[Docket No. FAA-2023-0668; Project Identifier AD-2023-00199-R; Amendment 39-22453; AD 2023-11-07]

Airworthiness Directives; Various Helicopters

ACTION: Final rule; request for comments.

Figure 1 to paragraph (g)(1)(i) – *Fundamental Effective Isotropic PSD at Outside Interface of Rotorcraft Antenna*

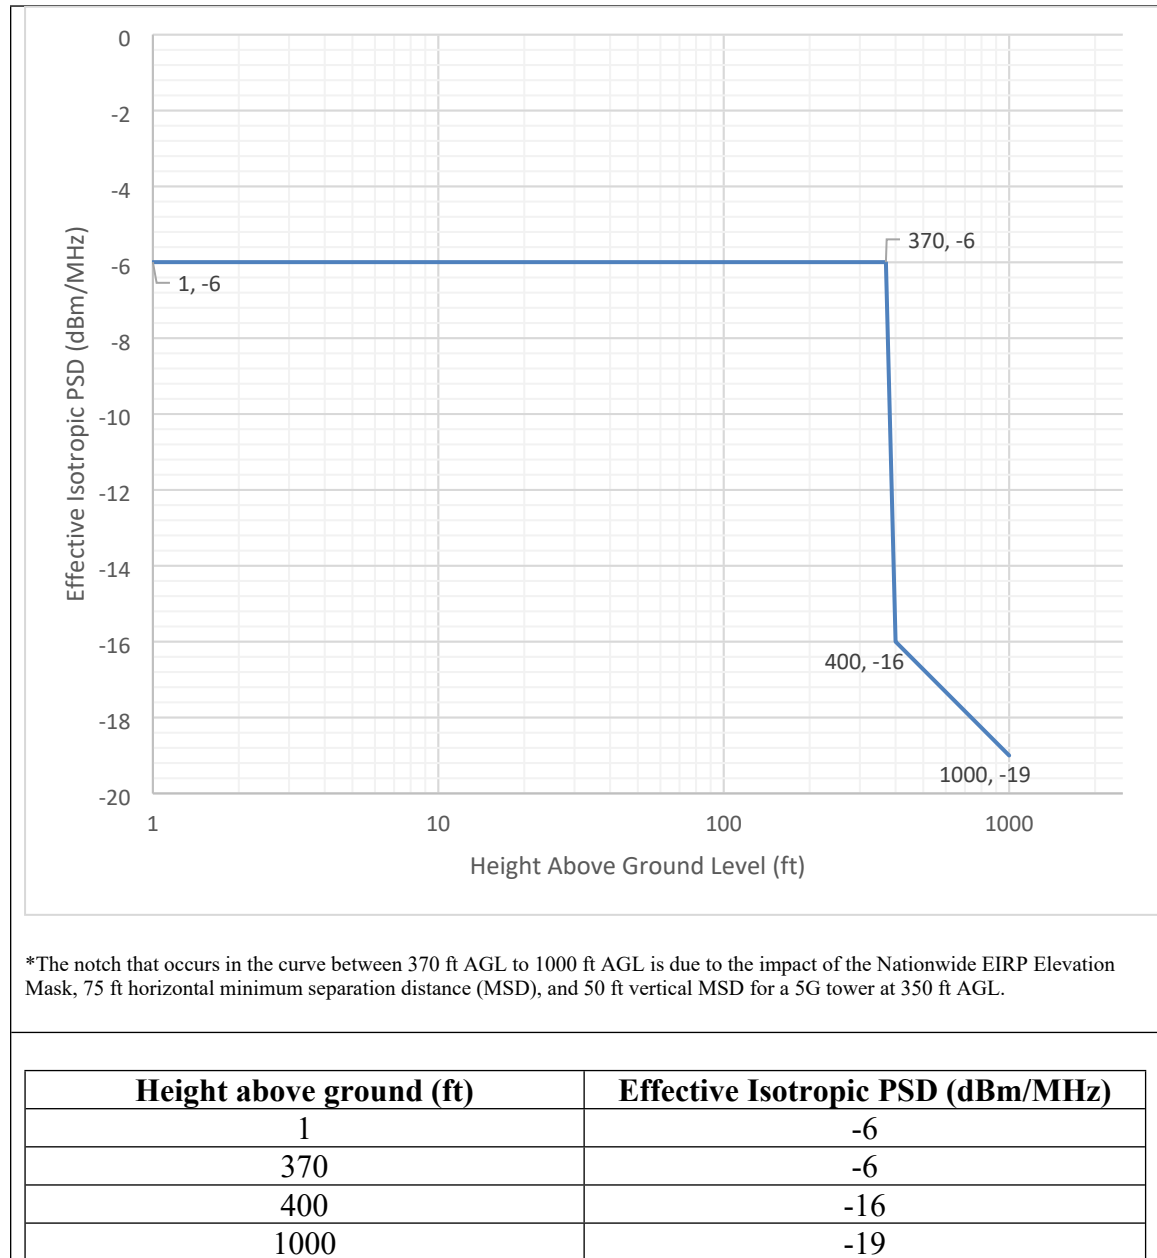
Comment summary: Thales and Sikorsky requested the FAA clarify several aspects of the PSD curve in figure 1 to paragraph (g)(1) of the proposed AD: whether no elevation mask is taken into account at and below 350 feet above ground level (AGL); at which base station emission power the PSD curve corresponds (62 dBm/MHz or 65 dBm/MHz); and whether the radio altimeter performance criteria in the curve explicitly

covers any 5G emitter station up to 65dBm/MHz in the applicable 3.7–3.98 GHz band, for the foreseeable future. Sikorsky requested that the FAA revise the proposed AD to include a PSD curve that reflects the reduced EIRP levels for helicopters operating at the 188 priority airports (5G CMAs) with reduced power levels.

Comment summary: Sikorsky requested the FAA revise the PSD curve in figure 1 to paragraph (g)(1) of the proposed AD to change the height above ground at -6 dBm/MHz from 270 feet to 370 feet, and at -16 dBm/MHz from 300 feet to 400 feet. Sikorsky stated its request was based on several factors, including the minimum safe obstacle avoidance distance and the typical decision height used for radio altimeter critical operations associated with missed approach points (MAPs) during point in space (PINS) approaches. Sikorsky further stated that radio altimeters are not operationally used above 1000 feet, and therefore there is little value for any PSD restrictions above 1000 feet operationally.

FAA response: The notch in the PSD curve does not mean that no elevation mask is taken into account below 350 feet AGL. The elevation mask is taken into consideration below 350 feet AGL and is a fundamental consideration in how the PSD curve was established. The PSD curve was calibrated to cover 5G C-Band emitter stations up to 65 dBm/MHz in the applicable 3.7-3.98 GHz band.

The FAA disagrees with revising the AD to include a PSD curve for helicopters operating at airports with reduced power levels. The radio altimeter tolerant rotorcraft PSD curve was established to provide safe operation anywhere in the contiguous U.S. regardless of whether a helicopter is operating at a 5G CMA.

FAA response: The FAA assumed an emitter base station height of 350 feet based on consensus reached in rotorcraft industry group meetings. Additionally, FAA analysis of existing emitter base station height data shows that, while higher emitters do exist, they are infrequently adjacent to helipads. Second, the FAA assumed the rotorcraft was

no closer than 50 feet above and 75 feet laterally from the emitter. The vertical distance was based on pilot feedback and the lateral distance was based on common lateral separation from the main rotor tip recommendations of 2 main rotor diameters from the tip of the rotor, selecting a 30 foot rotor as the smallest rotor in this class of aircraft with the antenna under the main rotor mast. An operator of an individual model rotorcraft with a larger rotor diameter may request approval of an AMOC to the AD on the basis of separation distance. Third, the FAA assumed that the emitter was active at the full rural power level of 65 dBm/MHz allowed in FCC Report and Order FCC 20-22.² The FAA then evaluated the resulting curve against data from radio altimeters and found it to be achievable with current technology using filters that have been developed. Based on data from existing emitters, if the height reduction from 370 feet to 270 feet, as requested by the commenter, were adopted, it would result in many more landing scenarios unprotected from interference because emitters on towers at about 250 feet as opposed to the accepted assumption of 350 feet are much more common. For this reason, the FAA did not adopt this request.

The FAA has re-evaluated the need for PSD performance requirements above 1000 feet and agrees with the reasons provided by the commenter. The PSD curves specified in this AD have been changed accordingly.

Figure 2 to paragraph (g)(1)(ii): *Spurious Effective Isotropic PSD at Outside Interface of Rotorcraft Antenna*

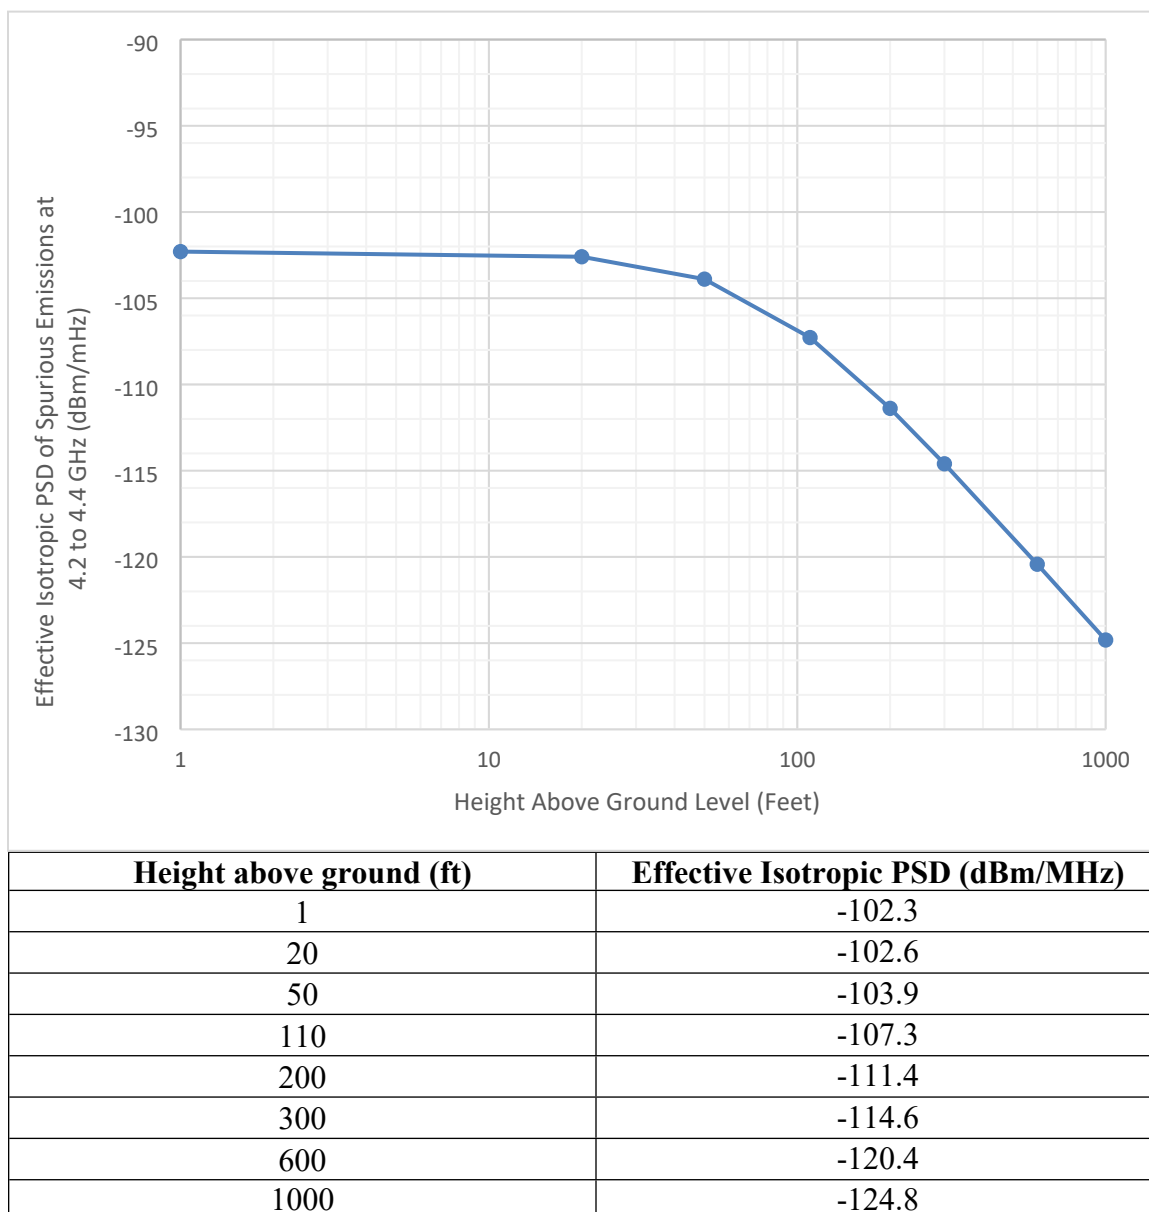
Comment summary: HAI, Sikorsky, and Thales requested that the FAA revise the proposed AD to include the frequency range to which the PSD tolerance curve thresholds apply, a new figure indicating the spurious tolerance similar to the figure with the PSD tolerance curve, and a specification of the altitude dependence for spurious tolerance.

In this final rule, the FAA replaced the proposed fixed aggregate spurious emission level of -42 dBm/MHz (conducted) with a spurious PSD tolerance curve for 5G C-Band interference from a single base station. This form of the requirement is consistent with the transport and commuter category airplane requirement. Similarly, it does not include an aggregation factor or any base station or aircraft antenna gain factors. The spurious PSD tolerance curve is based on a different spurious emission level than what the FAA proposed in the NPRM (-30 dBm/MHz conducted for a single indoor base station instead of -48 dBm/MHz conducted for a single outdoor base station and an aggregation factor of 6 dB which yielded an effective aggregate level of -42 dBm/MHz).

As a result, the FAA is requesting comments on the spurious PSD tolerance curve in figure 2 to paragraph (g)(1)(ii) of this AD.

FAA response: The FAA agrees and has added the frequency range to the PSD tolerance curve. Additionally, as explained previously under “Actions Since the NPRM Was Issued,” the FAA has replaced the proposed fixed emission level with a spurious PSD tolerance curve.
